21154 PCI-to-PCI Bridge

Specification Update

July 2004

Figure 1. S_Clock Multiplexer Workaround Circuit for Errata 6.

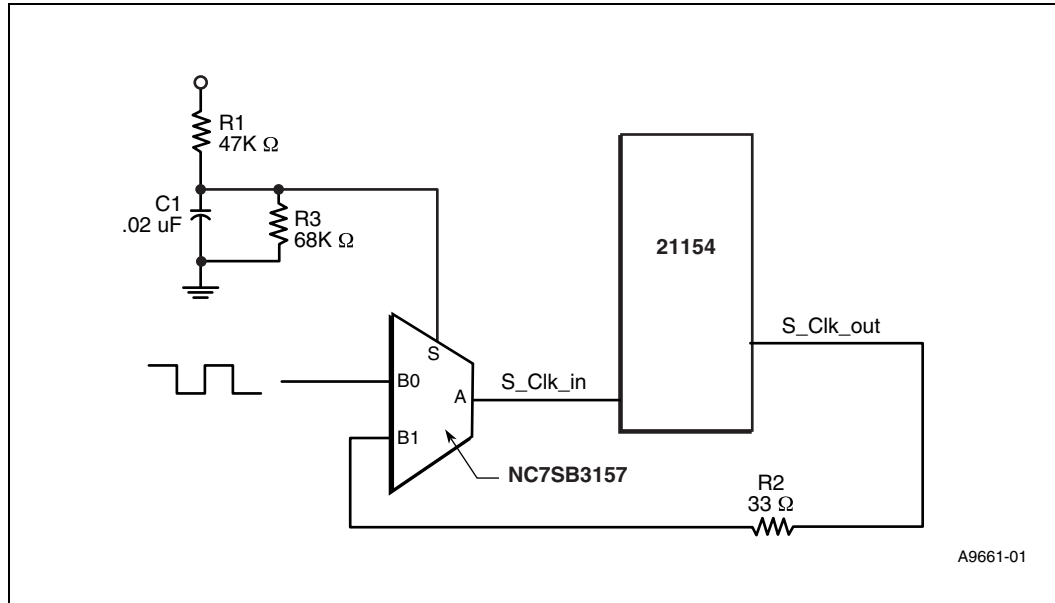
6. Secondary Clocks Outputs s_clk_o<9:0> May Not Start-up Properly Under Some Conditions

Problem: This problem has been found on the 21154AC and 21154BC. Under repeated and frequent power cycling, the secondary clock circuits may not power up in the proper state, resulting in the device not coming out of reset after power up.

Implication: In a system with a 21154AC or 21154BC that has one of its s_clk_o<9:0> outputs fed back to provide the s_clk, it is possible that the s_clk_o<9:0> output clocks will be driven and remain low, keeping s_rst_l asserted, during system power up.

1. [Figure 1](#) illustrates the first recommendation - a circuit where an on-board pulse source is gated via the B0 input of the multiplexer to the S_Clock_in pin of the 21150.

At time 0, the S input of the multiplexer is low, allowing pulses from the on-board pulse source, connected to the B0 input, to be provided to the 21150 S_Clk input pin. When the time determined by the R/C network is satisfied, the S input pin will be in a logic High state. The multiplexer will then shut off the input pulse from S0 and will direct the S_Clock_out pulses via the B1 multiplexer input, into S_Clock_in

The values used for the R/C network should be selected to allow a minimum of 2 pulses to be delivered to the 21150 after Vdd has reached 3.0V at a frequency not to exceed the appropriate PCI component. i.e. 30 ns for a 33Mhz bridge. These values should be chosen based on the rise time of the power supply and the frequency of the on board pulse source. The values given for R1, R3, and C1 are for example purposes only.

Note: The NC7SB3157 2:1 Multiplexer / Demultiplexer Bus Switch used in this example has a maximum propagation delay of 800ps that should be taken into consideration when matching trace lengths of the clock lines to avoid introducing excessive skew in the clocks. All S_Clock etch lengths must be matched to within 2ns @ 33Mhz or 1ns @ 66Mhz. The addition of this circuit requires that the etch length for the S_clock_in signal be reduced to compensate for the 800ps delay.

Figure 2. Recommended Circuit for a Tristable Buffer

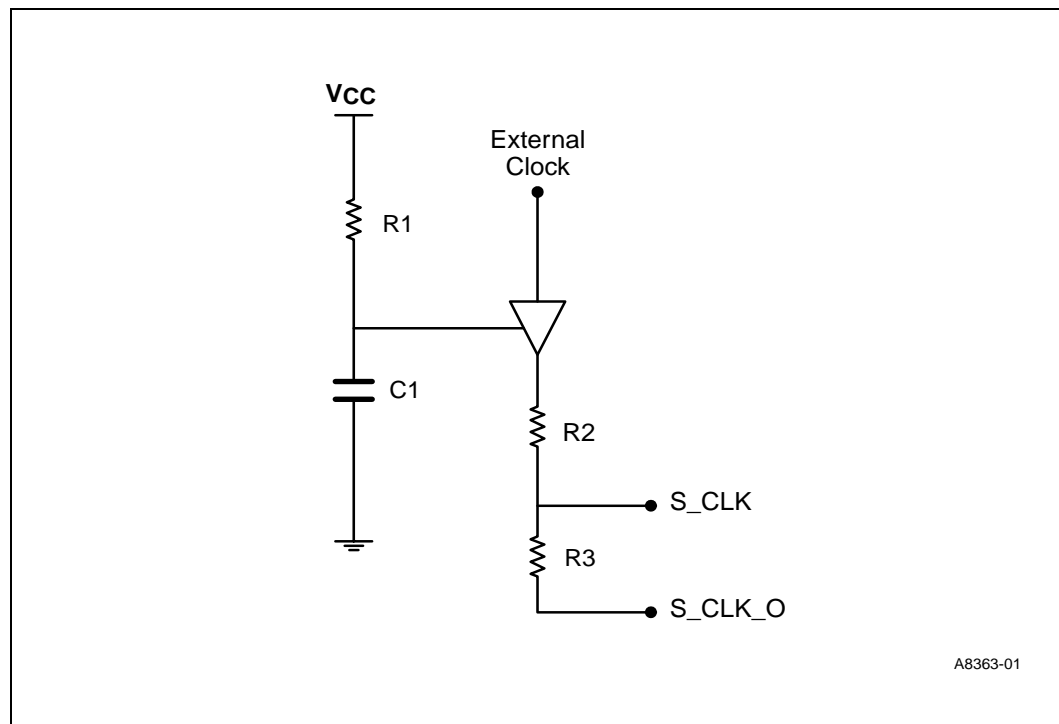
2. In the second recommendation, to guarantee the proper initialization of the **s_clk** circuits, the addition of an external circuit that provides a minimum of two transitions on the **s_clk** input during the power-up ramp is necessary. This can be done using a solution that drives an external clock onto the **s_clk** input while 3.3V Vcc is ramping during power up.

Figure 2 illustrates the use of a tristable buffer to provide multiple pulses to the **s_clk** input. The Vcc ramp rate and R1,C1 time constant determine the duration and amplitude of the pulses generated during power up. The R2-R3 values are chosen based on applicable board etch impedance-matching requirements.

The following should be considered in calculating the R1,C1 time constant:

- Make the time constant of the circuit as short as possible, while still ensuring that a minimum of two pulses are generated during the Vcc ramp.
- Phase delay between **s_clk_o** and the external clock should be minimized.
- Matching the external clock and **s_clk_o** frequencies to reduce contention.
- Laboratory experiments using **p_clk** as the external clock and a R1C1 time constant between 40 and 60 percent of the Vcc ramp have been successful using this configuration. However the use of **p_clk** as the external clock violates the PCI bus specification for loading of the primary clock.

Figure 6. Removal of Pull-Down Resistor for JTAG Testing

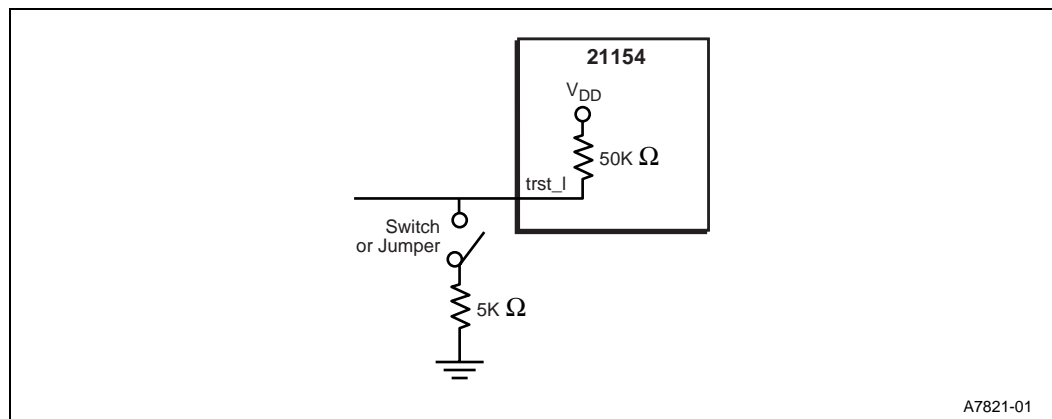
9. Section 6.3.1, Signal trst_l Pull-Down Resistor, New Section

A 5 K Ω pull-down resistor is required on trst_l for normal PCI-to-PCI bridge operation. However, some JTAG test results may be inconclusive if the 5 K Ω resistor remains in the circuit. To obtain accurate JTAG results, Intel recommends one of the following solutions:

- Verify that the JTAG test equipment, after driving trst_l low to reset the TAP controller, constantly drives trst_l high during JTAG tests. If this signal is not constantly driven high, the 5 K Ω resistor will pull the signal to a low state.
- Remove the 5 K Ω resistor during JTAG tests. This resistor must be installed during normal PCI-to-PCI bridge operation.
- Design external circuits with a switch or jumper to isolate the 5 K Ω resistor during JTAG tests (see Figure 6). This switch must enable the resistor during normal PCI-to-PCI bridge operation.

Figure 19 Example of GPIO Clock Mask Implementation on the System Board

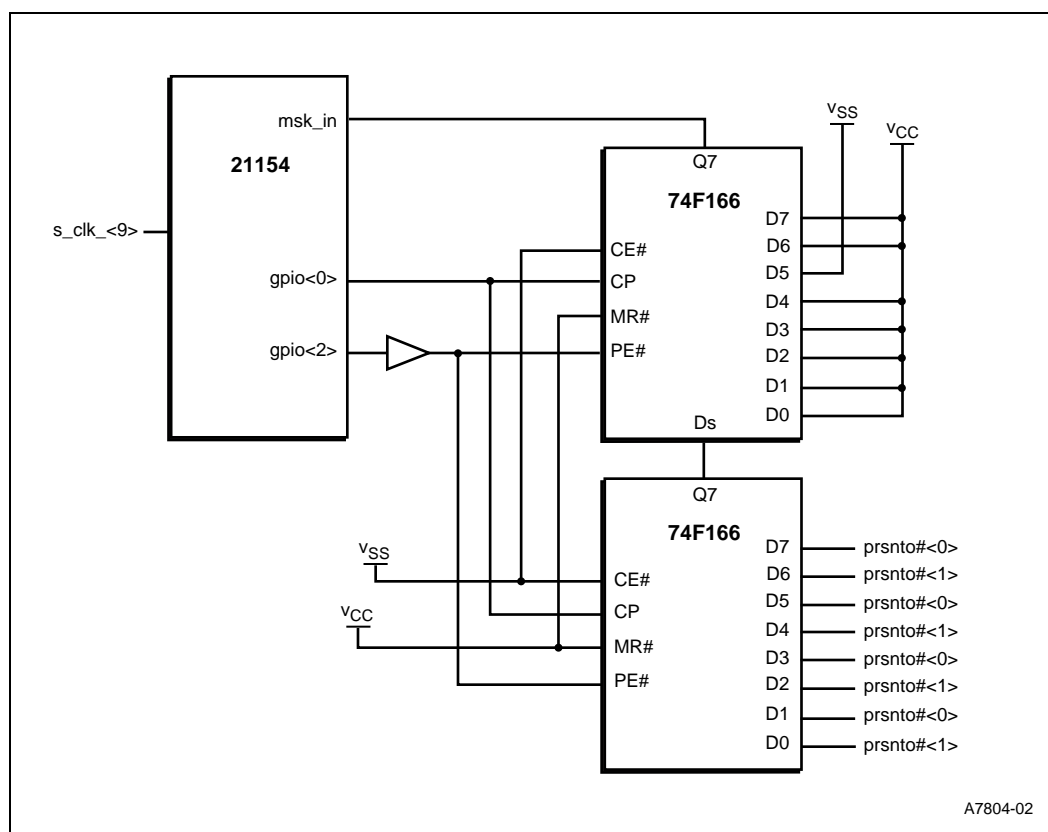
12. Section 10.2, Secondary Clock Control, Figure 19

This figure now appears as follows:

Figure 20. Clock Mask and Load Shift Timing

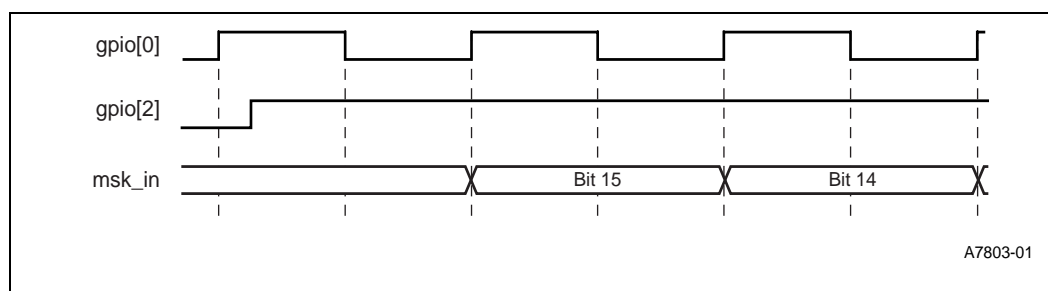
13. Section 10.2, Secondary Clock Control, Figure 20

This figure now appears as follows:

Figure 21. Clock Mask and Load Shift Timing**16. Section 15.1.3, Primary Command Register, Table Description**

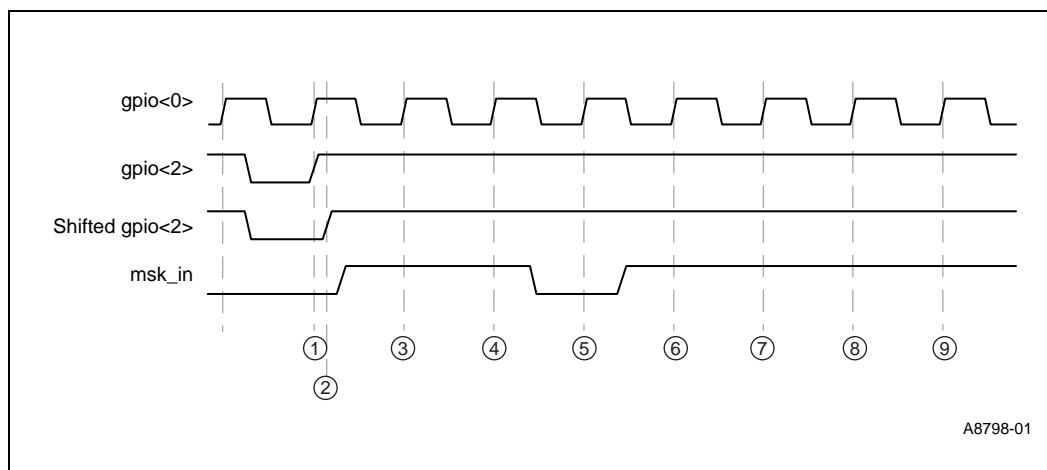
15. Section 10.2.1, Mask and Load Shift Timing Events for 66 MHz Operation

The following new section has been added:

The following list provides the timing sequence for 66 MHz operation for an example circuit as shown in [Figure 19](#) and the timing diagram in [Figure 21](#).

1. The **gpio<2>** original coming from the 21154 does not provide 3ns setup time needed to provide the parallel load enable **PE#** of the 74F166.
2. The shifted **gpio<2>** is delayed by ~9ns to provide ample setup time to enable the parallel of the shift register connected to pin 15 of the 74F166.
3. Bit 15 input **D6** of the shift register is pulled high, to Vcc.
4. Bit 14 input **D7** is pulled high, to Vcc. These signals are not used internally in the 21154.
5. Bit 13 **s_clk_o<9>** is a feedback to the 21154 **s_clk_o** input. To enable **s_clk_o<9>** in all cases the **D5** input of the shift register is grounded, to Vss.
6. Bit 12 **s_clk_o<8>** is disabled.
7. Bit 11 **s_clk_o<7>** is disabled.
8. Bit 10 **s_clk_o<6>** is disabled.
9. Bit 9 **s_clk_o<5>** is disabled.

Figure 3 Example of GPIO Clock Mask Implementation on the System Board

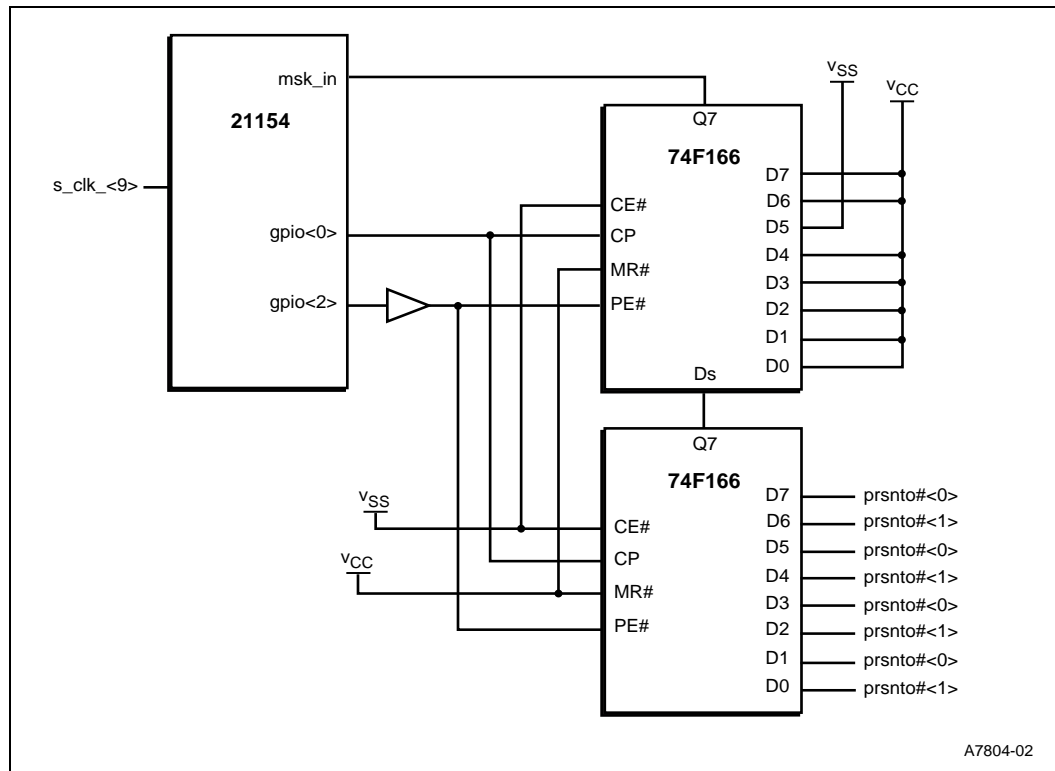
18. Section 4.4.1, Serial Clock Mask Shift, Figure 3

Figure 3 has been updated as follows:

Figure 4. Clock Mask Load and Shift Timing

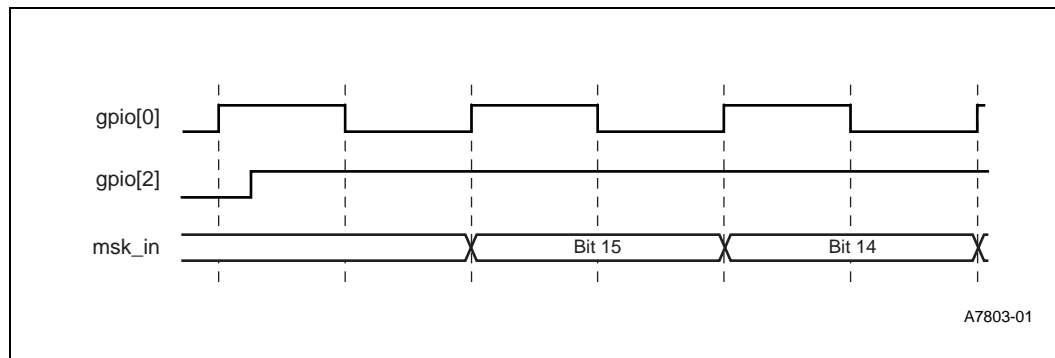
19. Section 4.4.1, Serial Clock Mask Shift, Figure 4

Figure 4 now appears as follows:
